TO:	Emily Wentworth, Town of Hingham	DATE:	March 30, 2016
FROM:	Joe SanClemente, P.E., AICP	HSH PROJECT NO.:	2015151.01
SUBJECT:	Avalon Hingham Shipyard II – 319 Lincoln Street Vanasse Traffic Peer Review – Response to Comments

Howard Stein Hudson (HSH) has prepared this memorandum in response to the comments received on the Avalon Hingham Shipyard II Project from the Town's peer review consultant, Vanasse & Associates, Inc. (VAI) in a memorandum dated March 10, 2016. Since that time the Proponent has reduced the scope of the Project to include just 190 residential units (60 fewer units) and associated adjustments to the site plan. HSH has prepared a technical memorandum documenting the change to the Proposed Project, the reduced traffic impacts, and the proposed mitigation.

Figure D.5. Fire Truck Turning Movements from U.S.S. Amesbury Drive to Service Aisle/Fire Lane

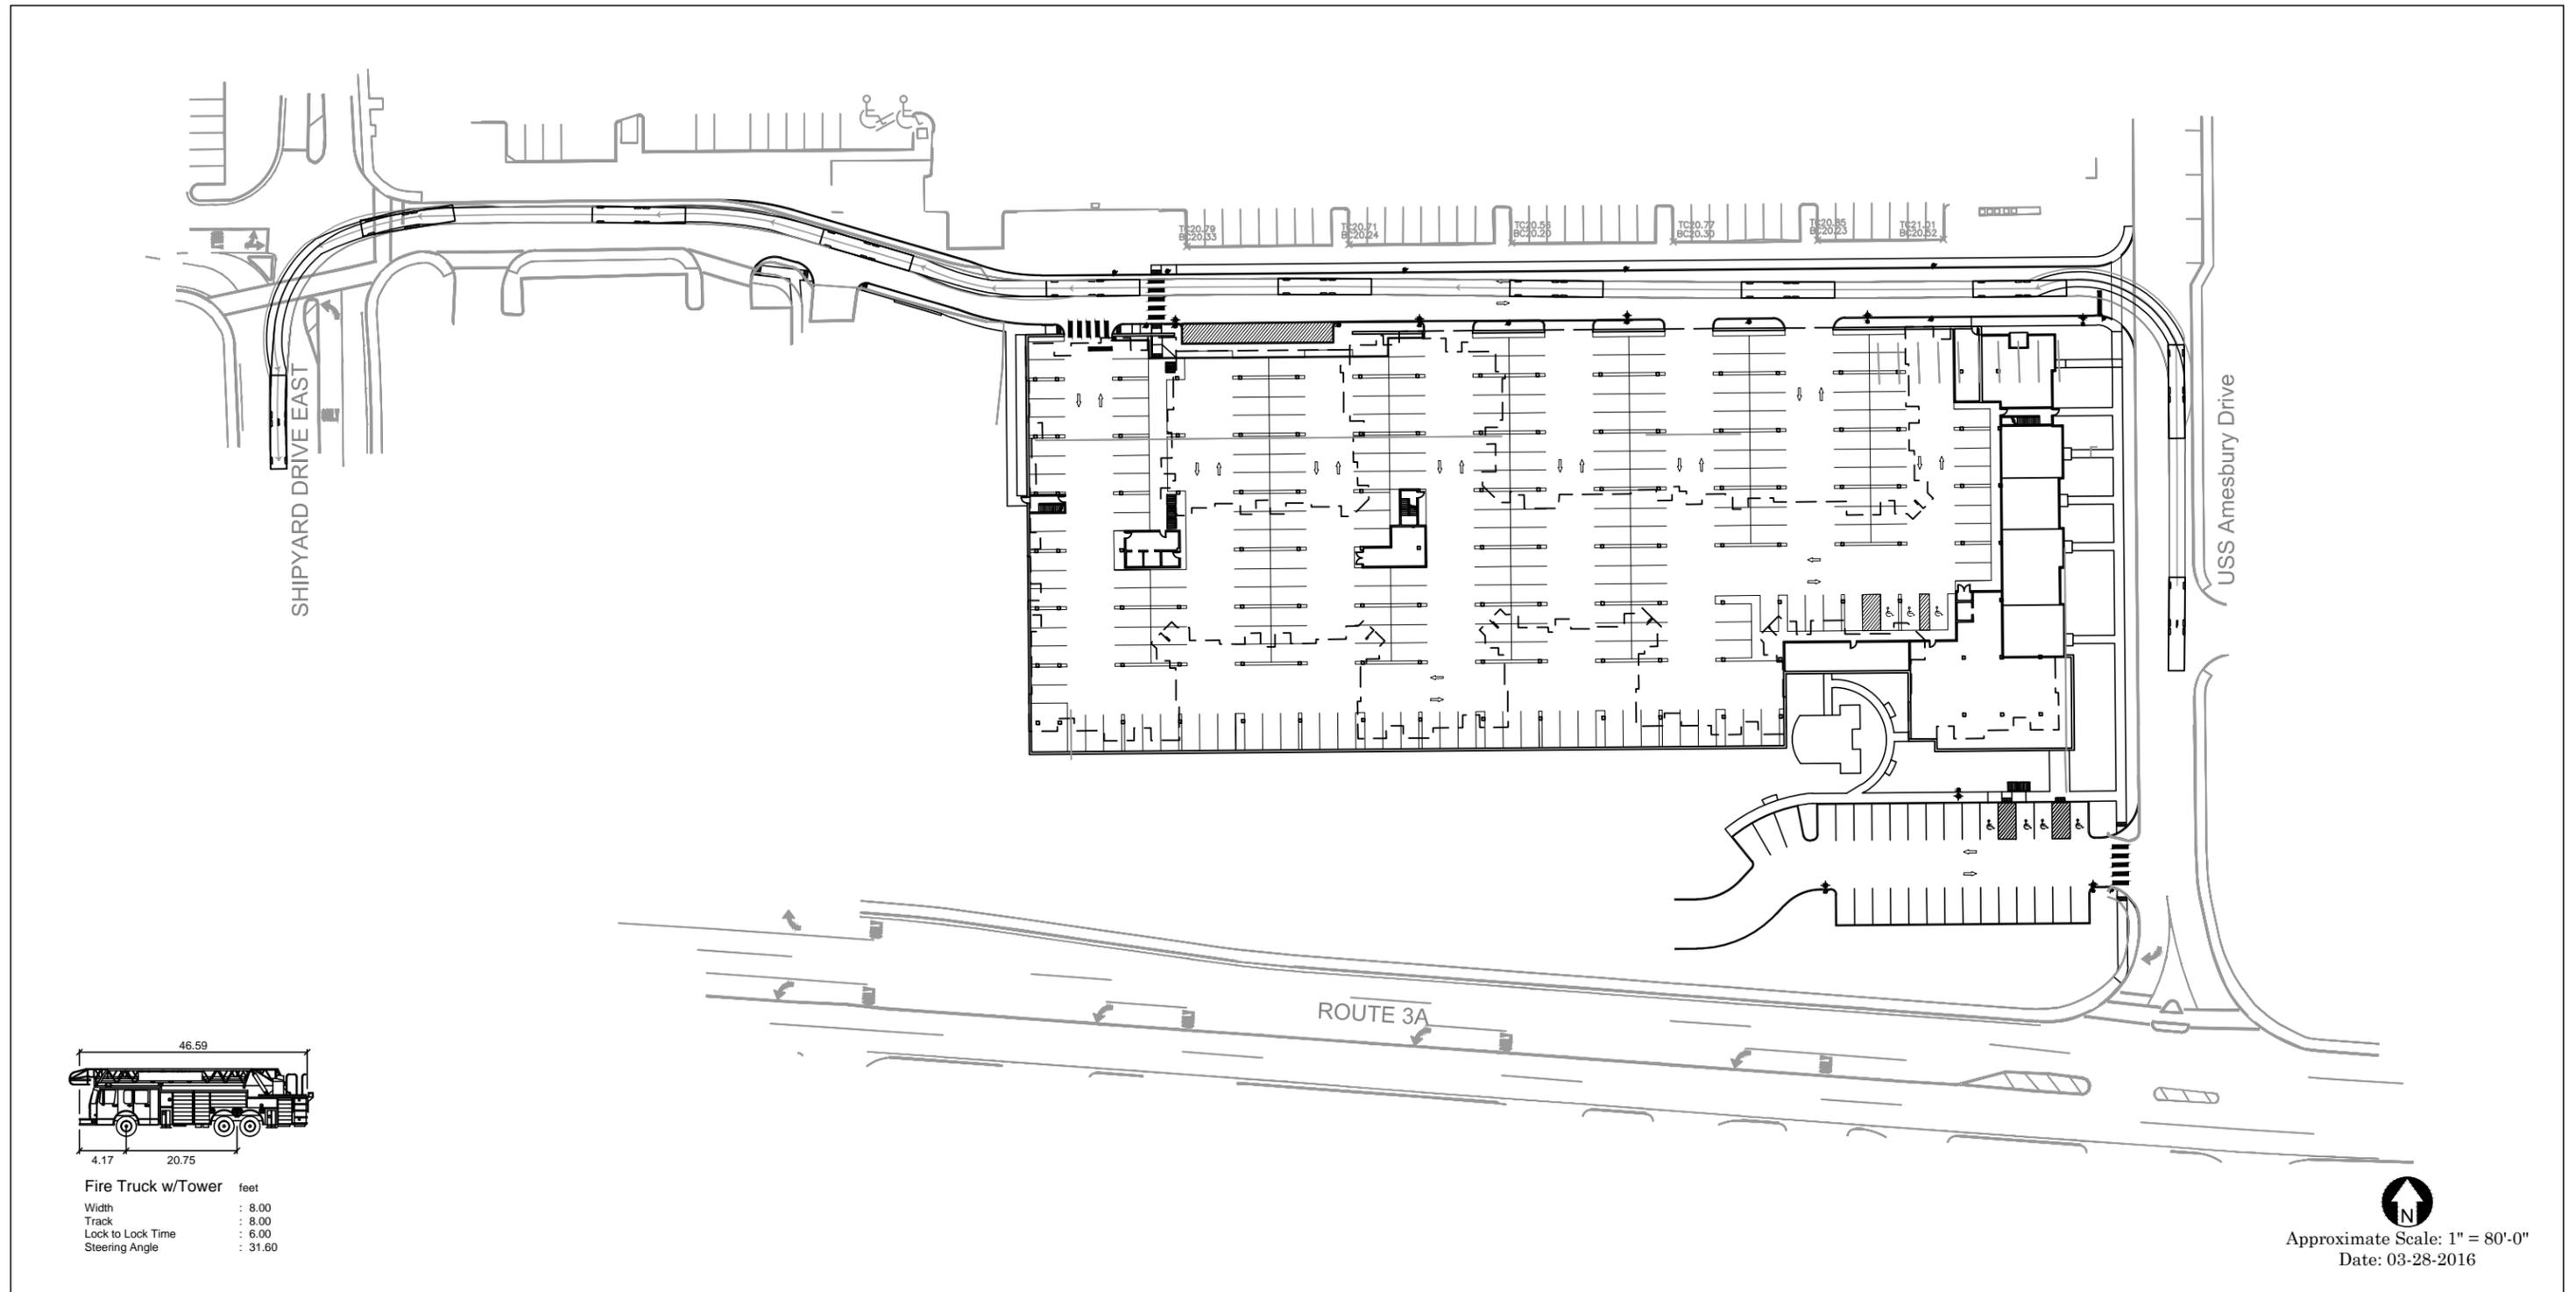
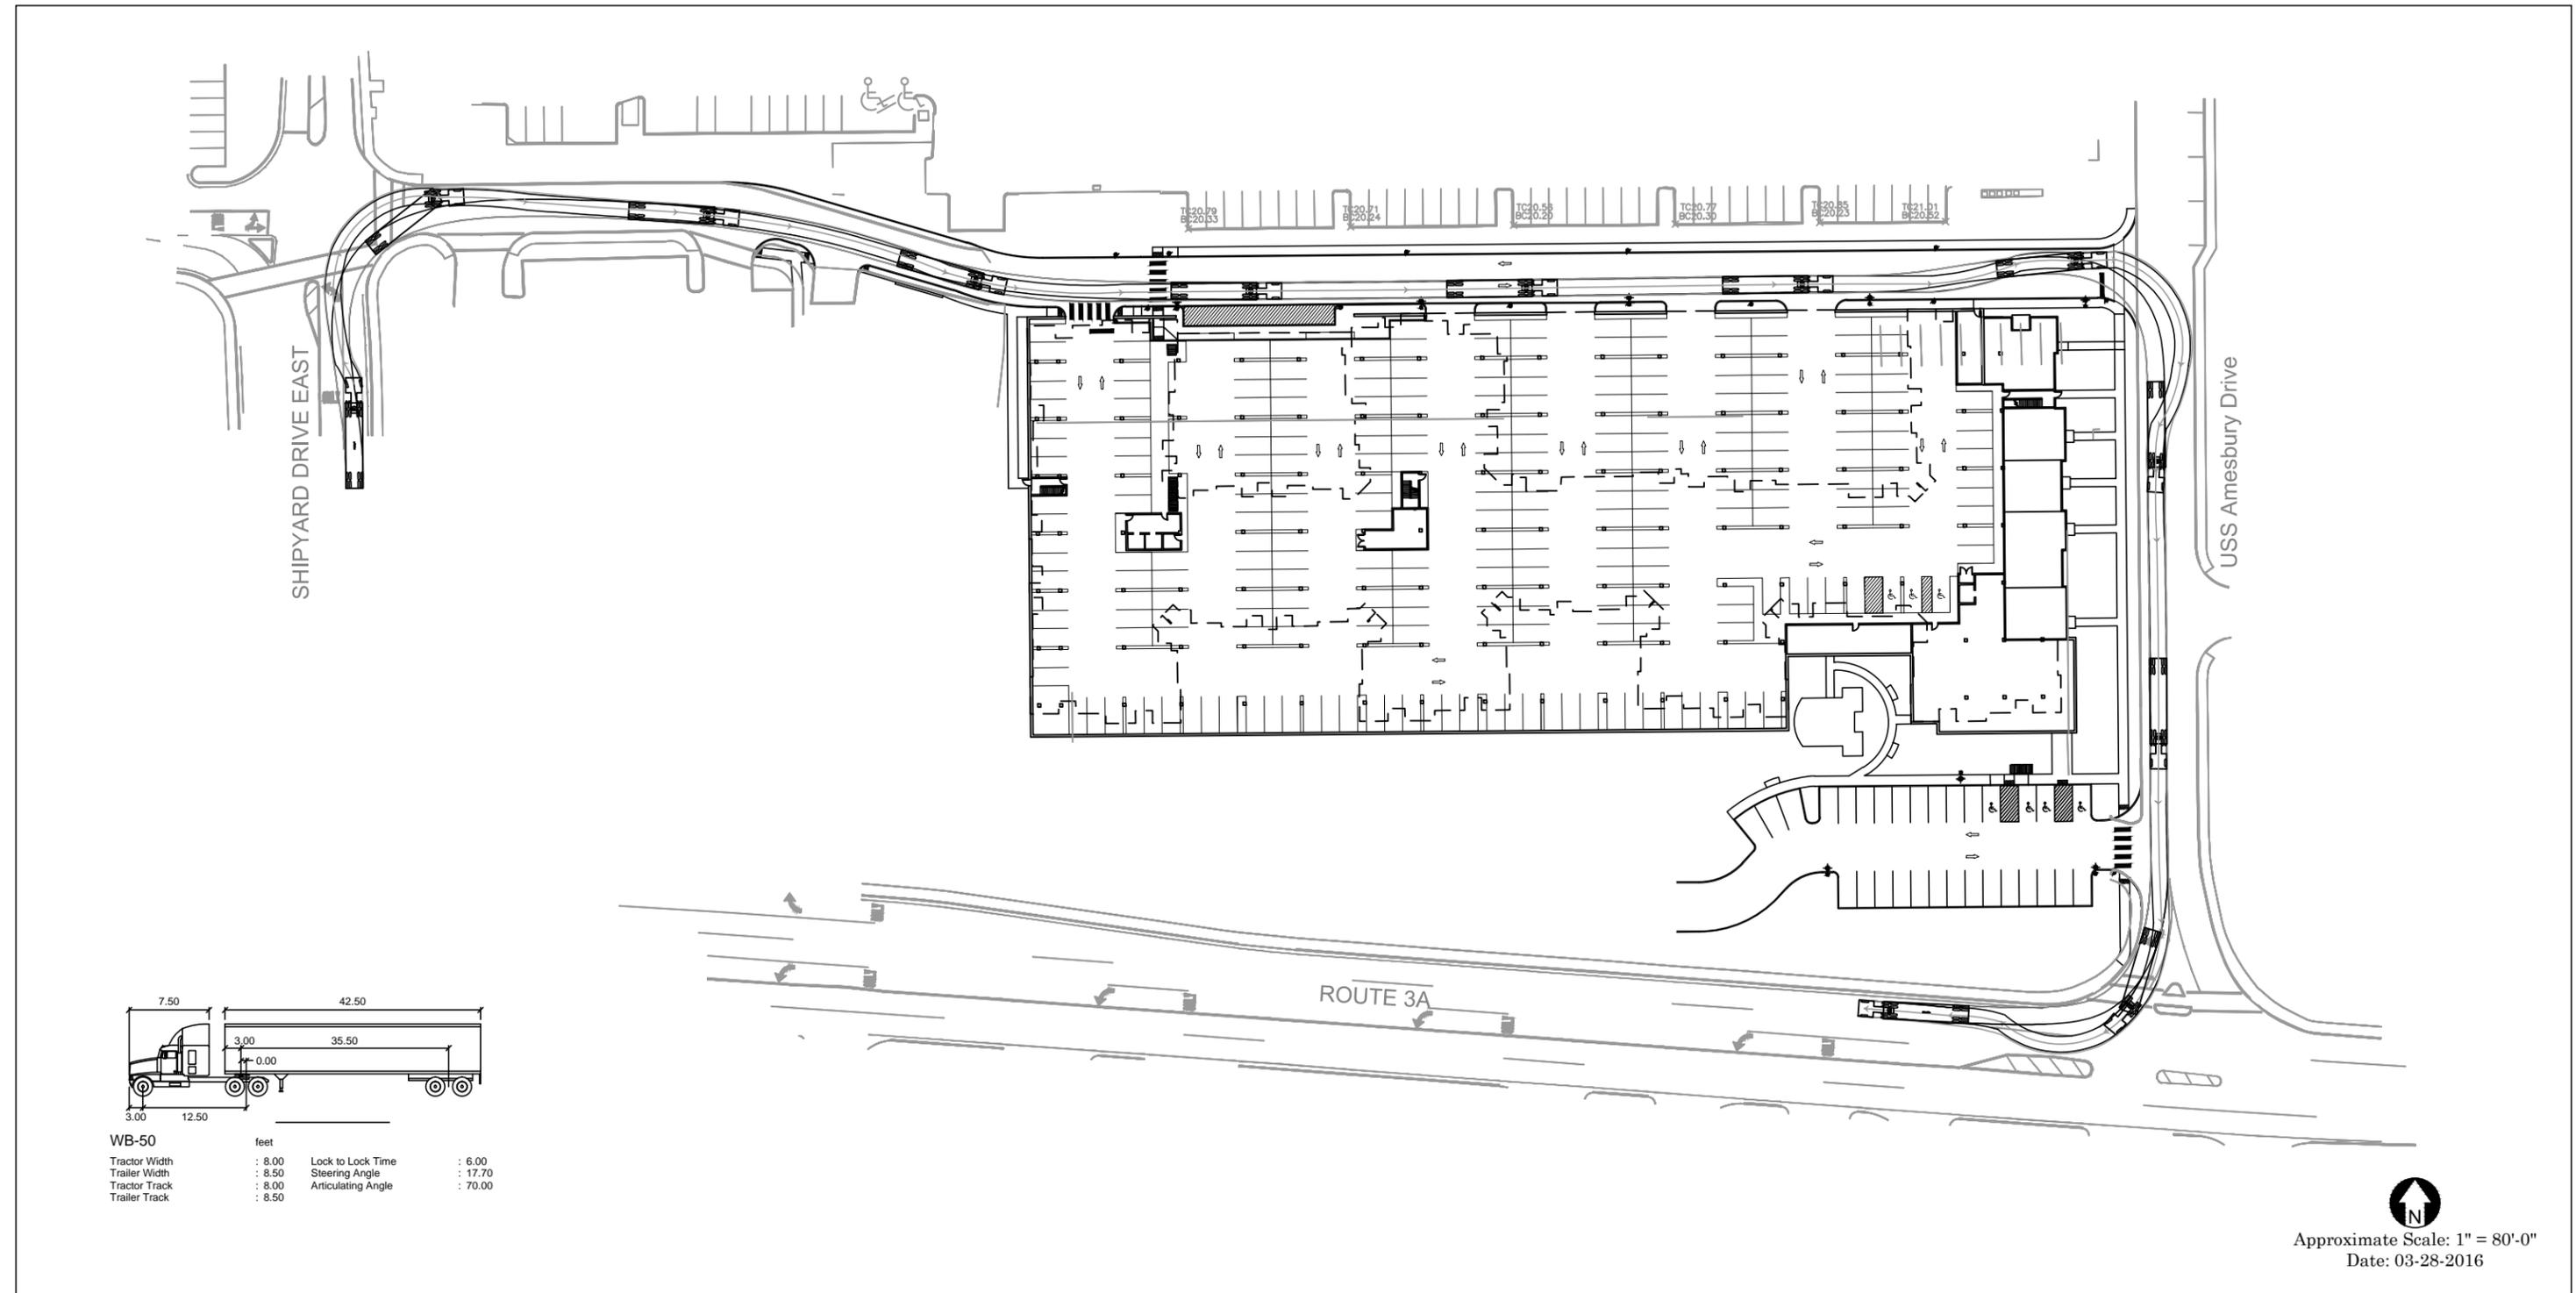
**Comment 1:** The Applicant's engineer provided a truck turning analysis for the Town of Hingham Fire Department design vehicle (tower truck) and an intermediate size tractor semi-trailer combination (WB-50). The turning analysis demonstrated that the subject vehicles can access and circulate within the Project site in an unimpeded manner; however, we note that the fire truck would need to back-up to exit the visitor parking area. The Applicant's engineer should also provide a turning analysis for an SU-30/40 (small delivery/moving vehicle and trash/recycling vehicle) that demonstrates that the subject vehicle can access and stage in the loading areas without blocking the garage access points. In addition, the analysis should also demonstrate the location and maneuvering required to serve the trash/recycling area.

Response 1: See attached truck turning analysis.
